SITE SURVEY REPORT

Stair and Guardrail Inspection

Prepared for	Poudre Valley Homes LLC
Date	8 Oct 2026
Site	Cottonwood Bend Duplex, Laporte, Colorado
Prepared by	J. Whitaker

Defects on this stair 1: D1

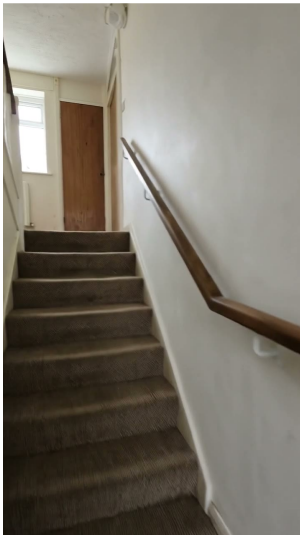
Defect reference	D1
Defect	Gap in guarding too wide
Where	Upper flight, open side, between balusters 6 and 7 counting from the landing
Measurement, if any (mm or in)	4.75
Priority	High
Made safe or taped off today?	No
Checks needing action on this stair	0
Defects recorded	1

Action	Add a baluster or respace balusters 6 and 7 on the Unit A upper flight so the gap is within the value entered, then remeasure.
Priority	Before handover
Who will do it	R. Delgado, finish carpenter, Front Range Trim LLC
Due by	13 Oct 2026
Status	Open
Actions still open	2
Decision	Use once the listed actions are done
Next check or re-inspection date	14 Oct 2026
Summary for the client	Both stairs measured within the values entered except one baluster gap on the Unit A upper flight. Unit B basement handrail has a loose bottom bracket. Both to be fixed and rechecked before handover.
Inspector name	J. Whitaker
Inspector signature
